TO: El Paso County
FROM: Element Engineering
DATE: March 25, 2023
SUBJECT: Town of Ramah Wastewater System Improvements Site Development Plan

EPC STORMWATER REVIEW COMMENTS
IN ORANGE BOXES WITH BLACK TEXT

TOWN OF RAMAH

WASTEWATER SYSTEM IMPROVEMENTS

WASTEWATER TREATMENT PLANT
FORCE MAIN PLAN & PROFILE 27+00 - 38+00
 TOWN OF RAMAH
 113 S. COMMERCIAL STREET
 RAMAH, CO 80832

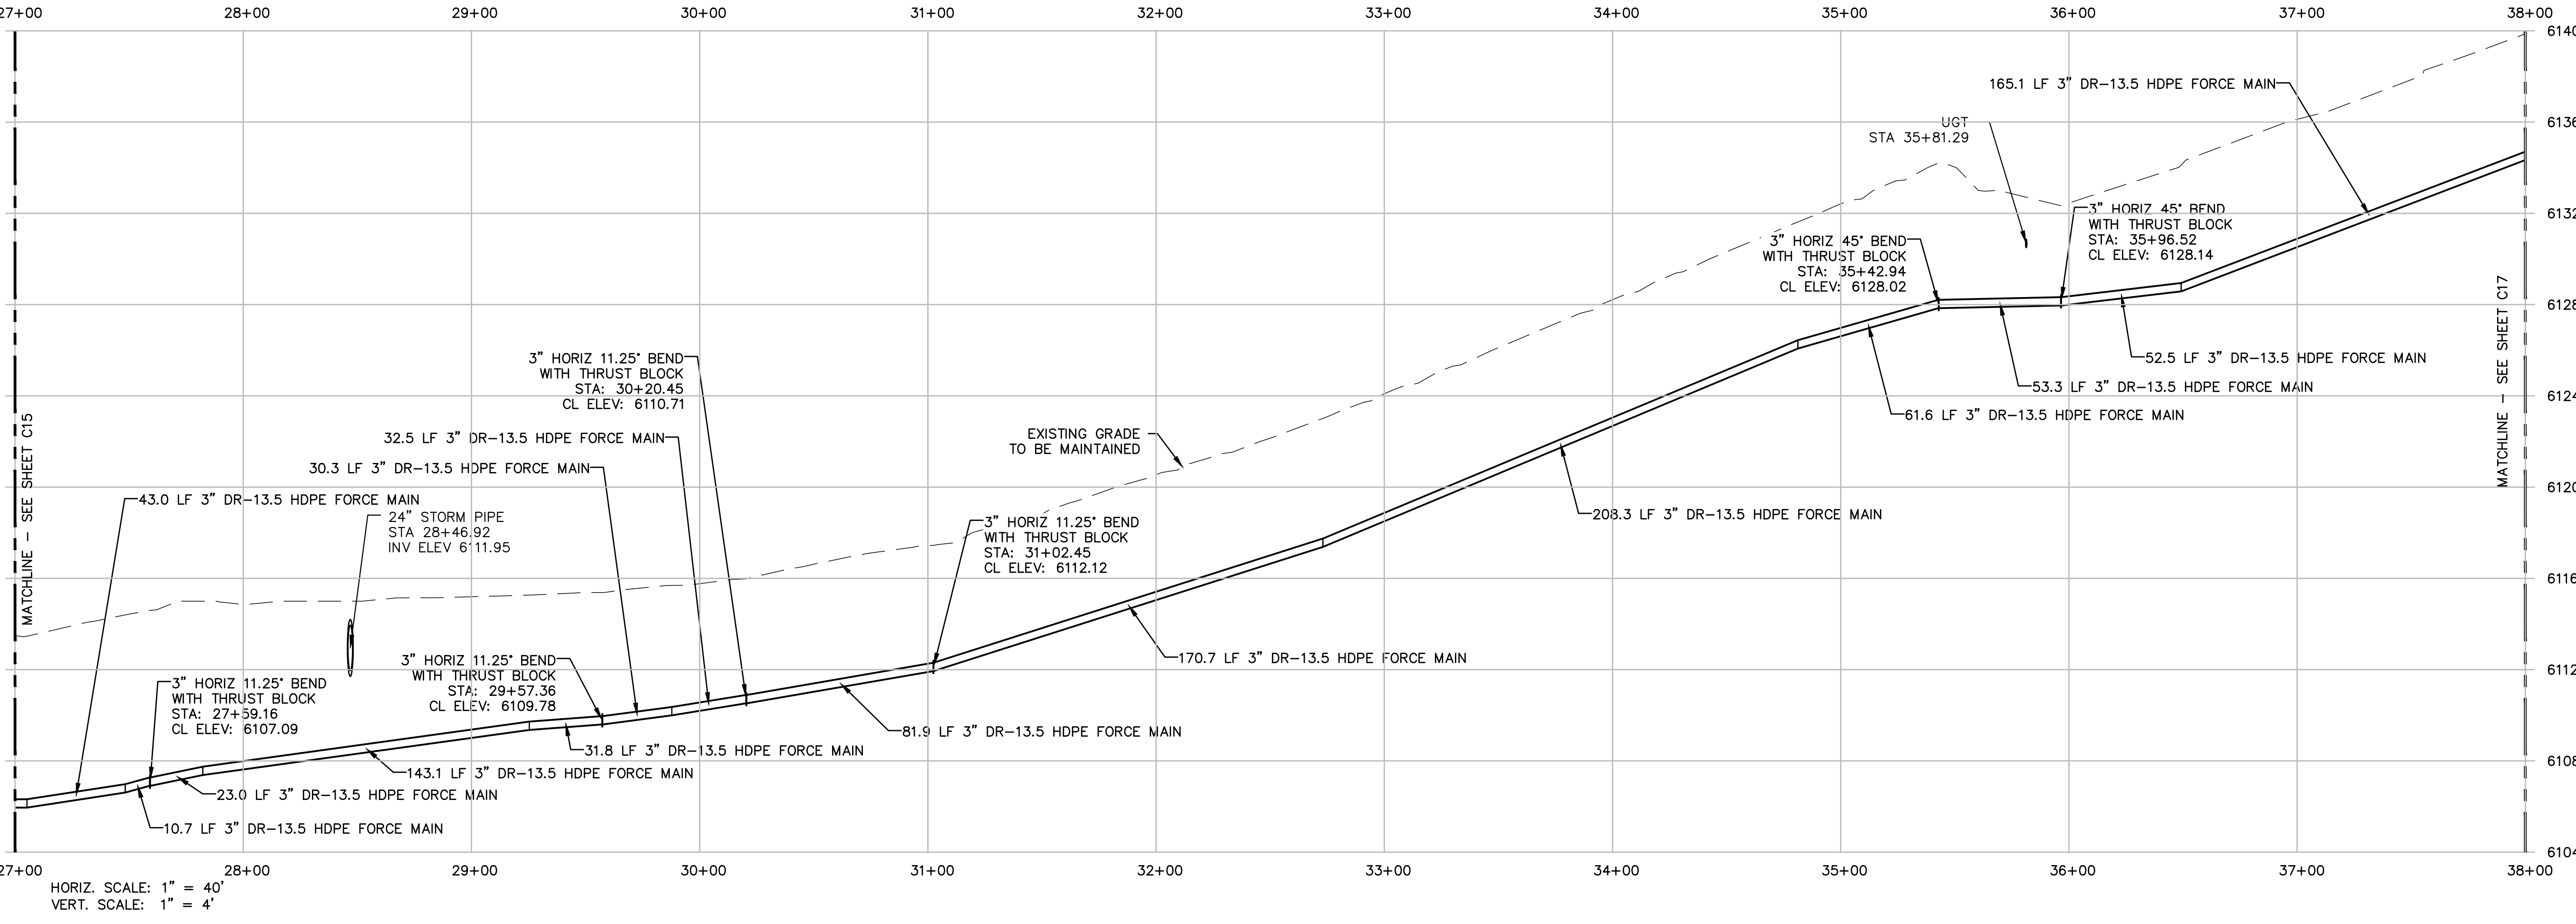
Please label and identify El Paso County ROW.

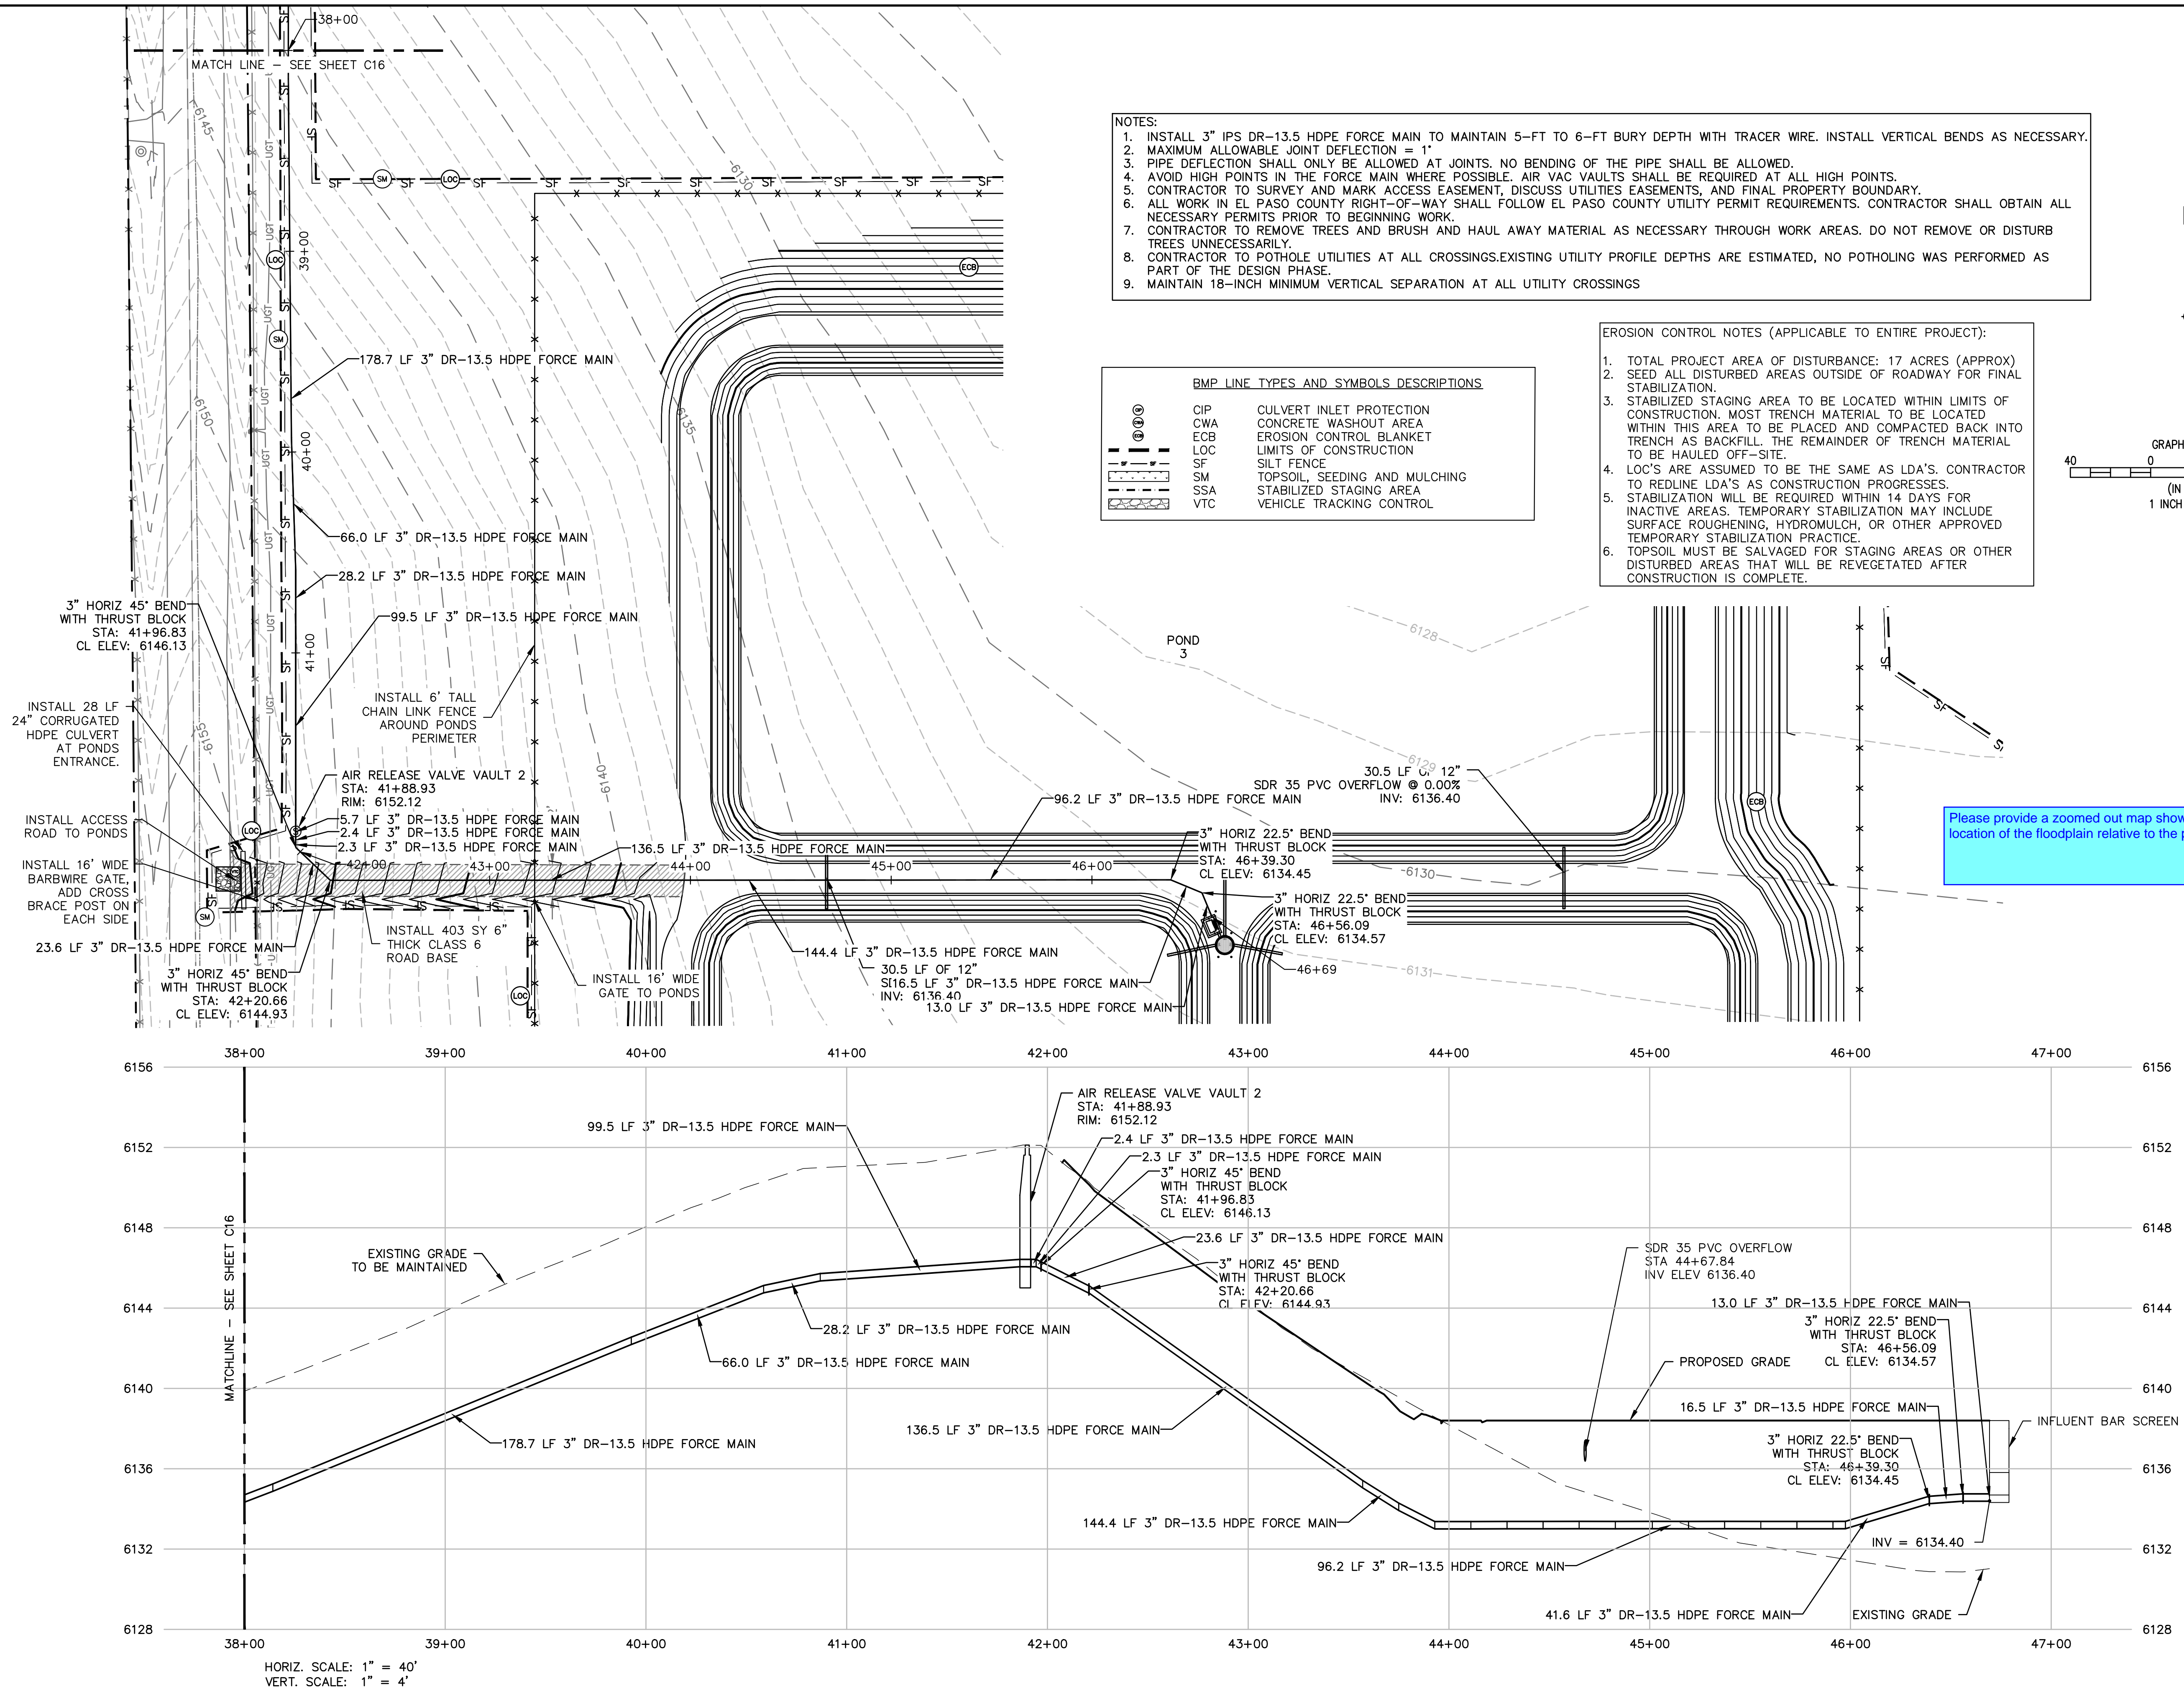
Please provide a zoomed out map showing the location of the floodplain relative to the ponds.

WASTEWATER TREATMENT PLANT
 HORIZONTAL CONTROL &
 GRADING
 TOWN OF RAMAH
 113 S. COMMERCIAL STREET
 RAMAH, CO 80832

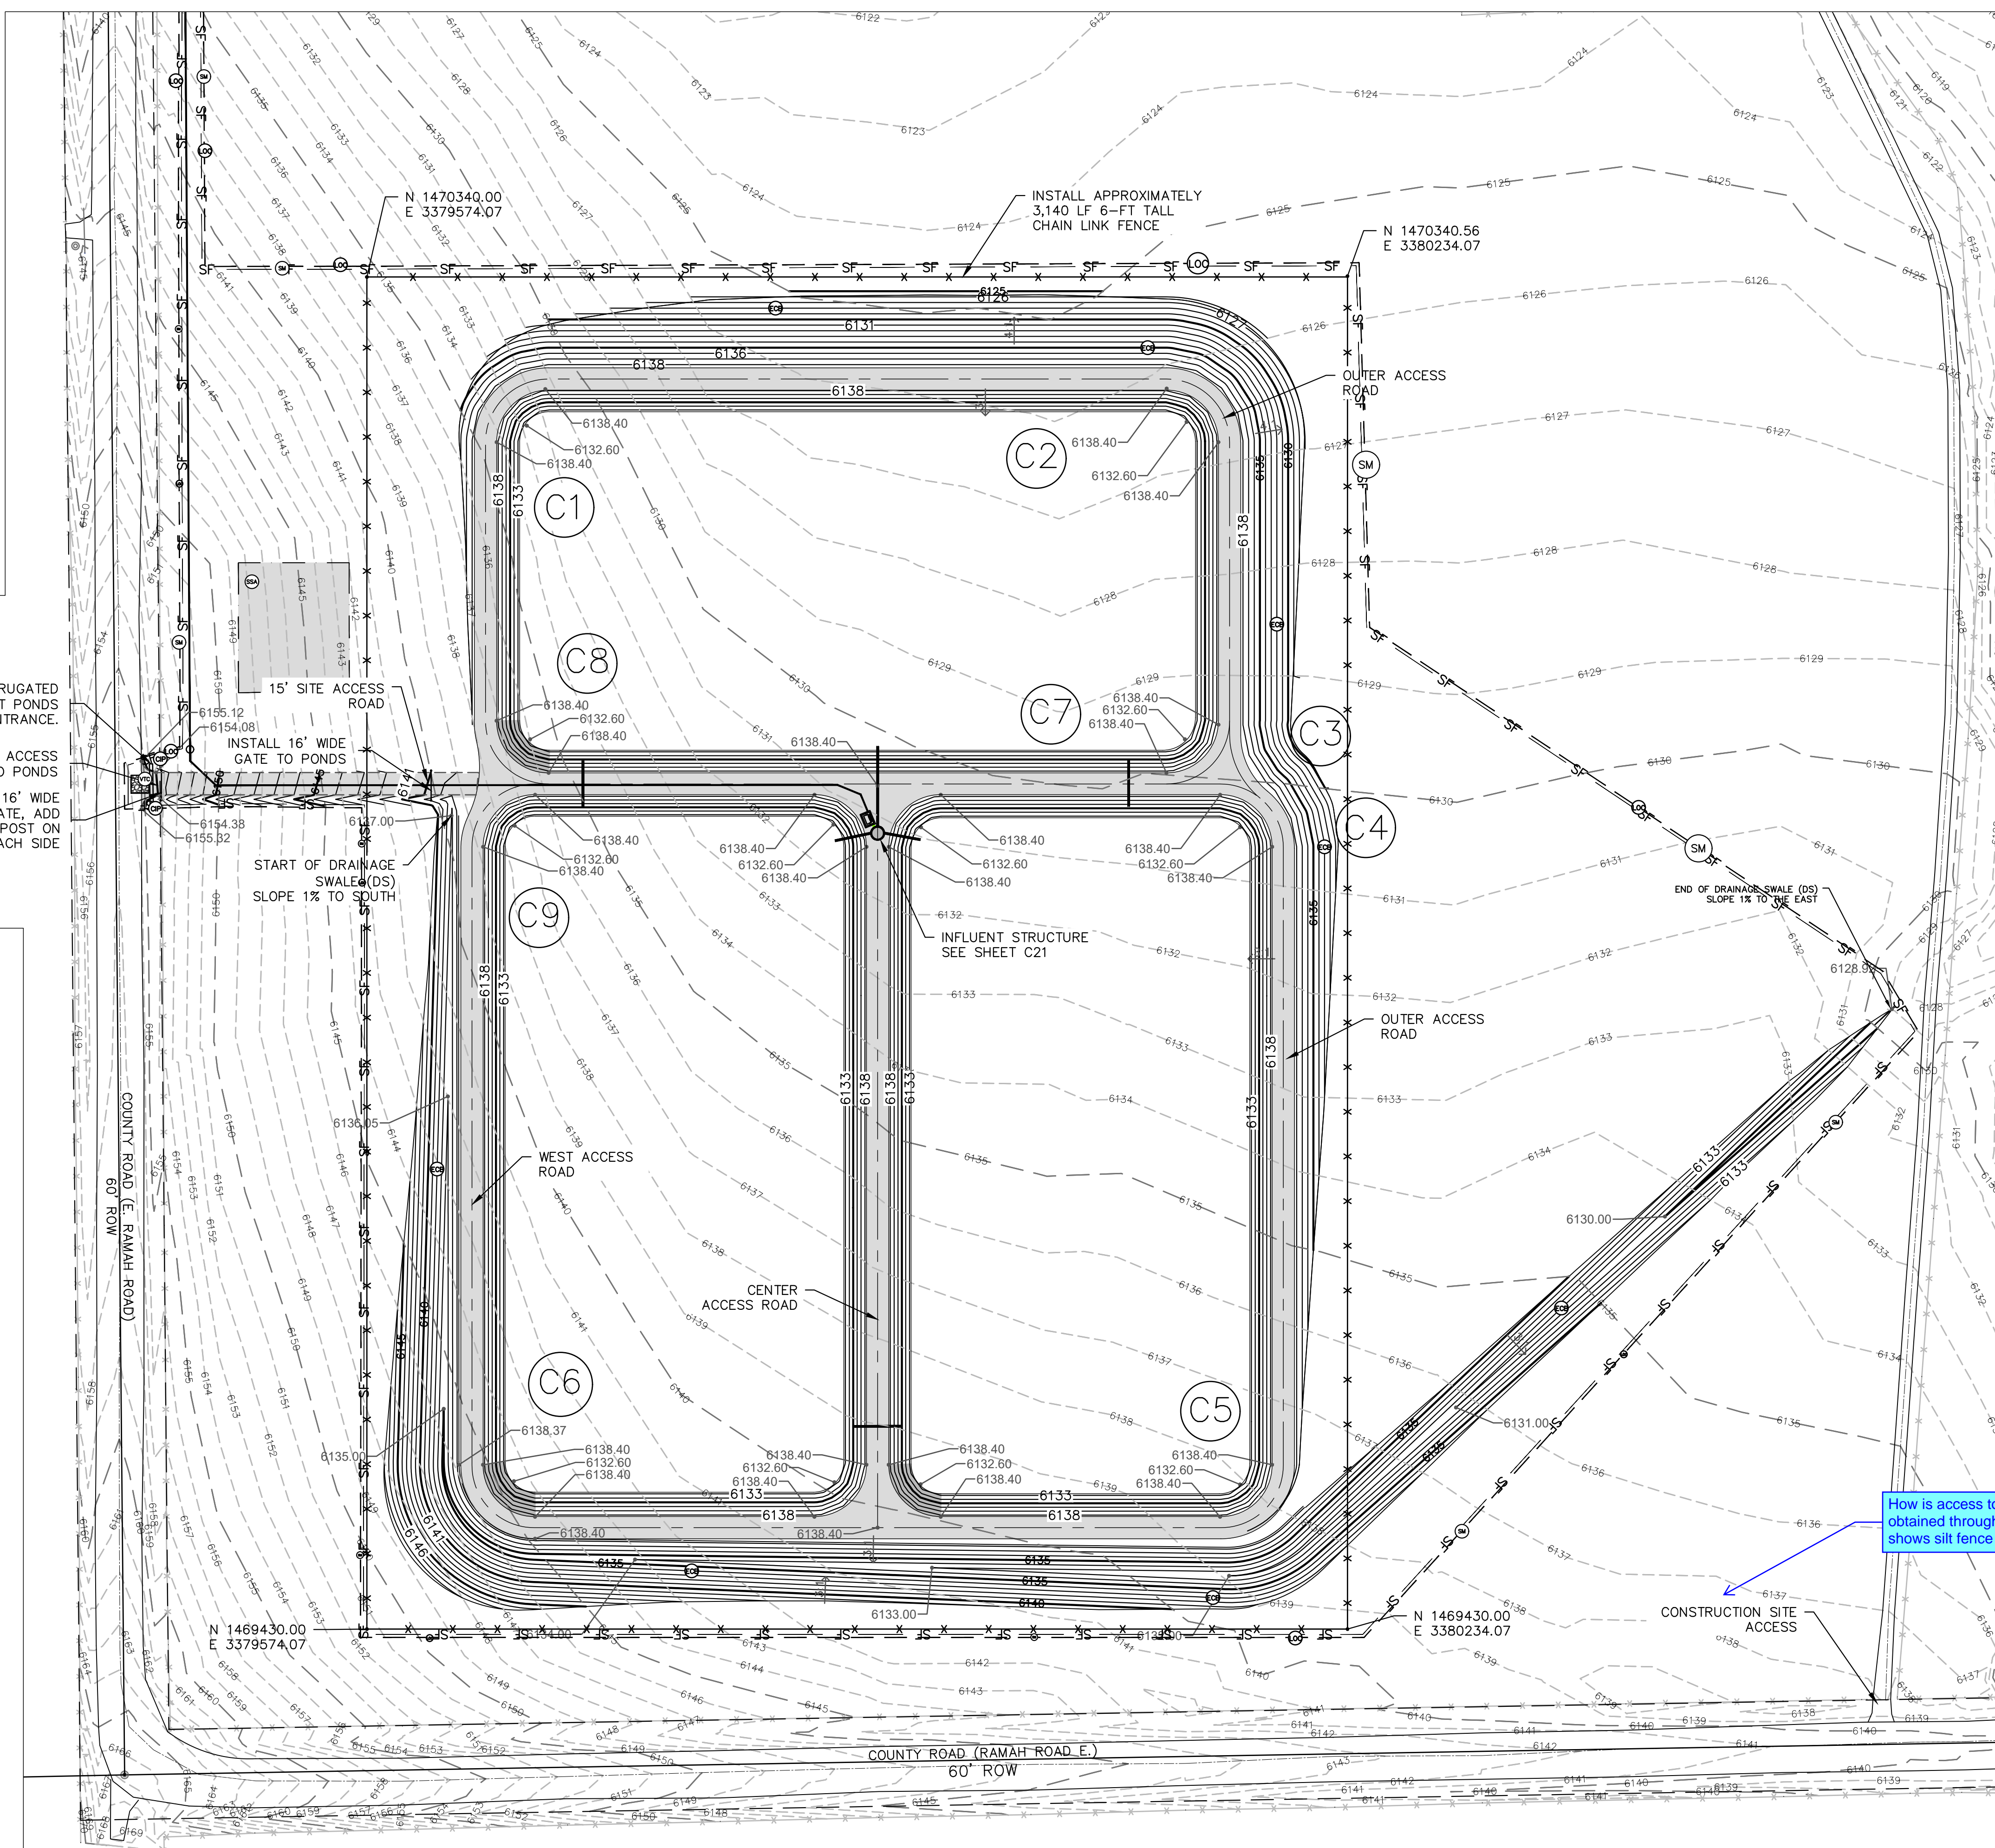
How is access to the construction site obtained through this driveway if the plan shows silt fence surrounding the property.
